P 515034-A
A49409

SEWAGE DISPOSAL SYSTEM
HOWARD COUNTY HEALTH DEPARTMENT
BUREAU OF ENVIRONMENTAL HEALTH
410-313-2640

SUBDIVISION Paternal Gift LOT NUMBER 20 ADDRESS 7105 Biter Lane

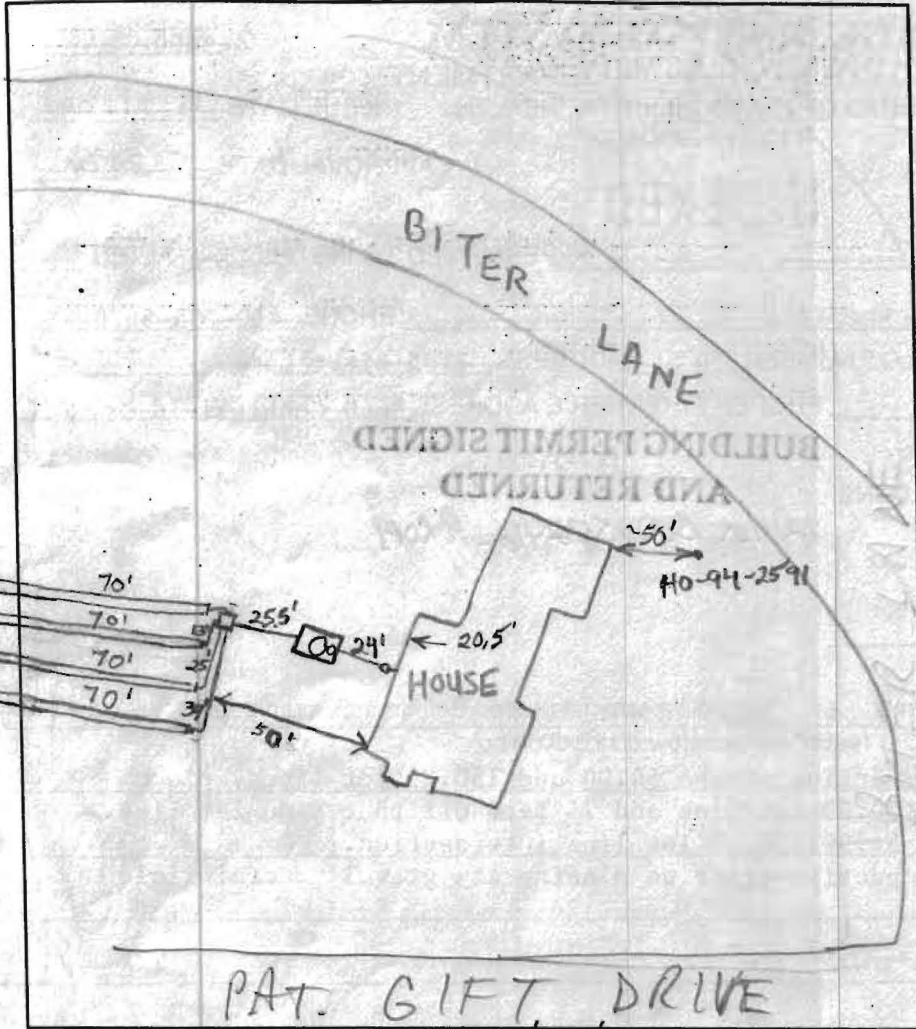
PRE-CONSTRUCTION INSPECTION: 5/21/01 OK TO START, TRENCH LAYOUT APPROX PER PLAN (40)

INSPECTION COMMENTS: 5/30/01 - TANK SET, NO OTHER WORK DONE, INSTALLER TO RUN 4 - 70' TRENCHES TOWARDS 150.23' LOT LINE (CONTOUR NOT AS SHOWN ON APPROVED BP PLAN BUT RUNS MORE PARALLEL TO 54.90' LOT LINE) - (ERK)

5/31/01 System satisfactory. O.K. to cover (BB)
